**PLANNING COMMISSION WORKSHOP AGENDA
HUMAN RESOURCES TRAINING ROOM
CITY HALL, 250 N 5TH STREET
THURSDAY, OCTOBER 5, 2023 - 12:00 PM**

Transportation Engineering Design Standards (TEDS) Update

2. Public Comments with City Response
3. Public Comments - draft TEDS

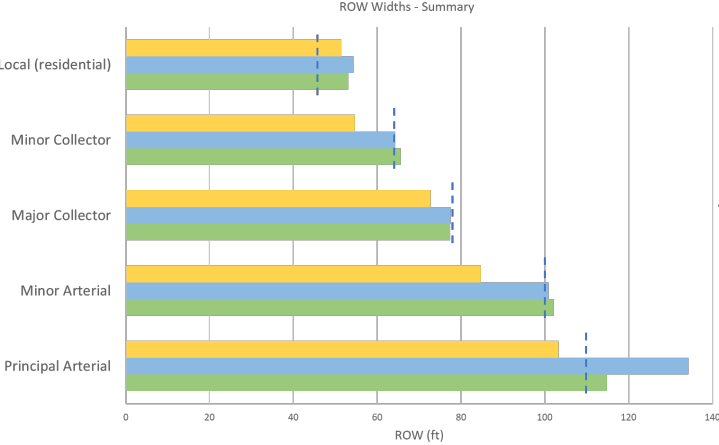
2	Issue: Right-of-Way size regulations and parameters. • Want further review and benchmark comparable cities. • Concern this reduces available land contributing to sprawl and decreases density.	Most street sections will see a wider roadway. However, for local streets, many options are available. • Local Street (currently 44’) – options vary between 38’ to 63’ in total ROW width.	• City researched peer cities. Proposed Sections are now benchmarked to peer Cities, see graph below:
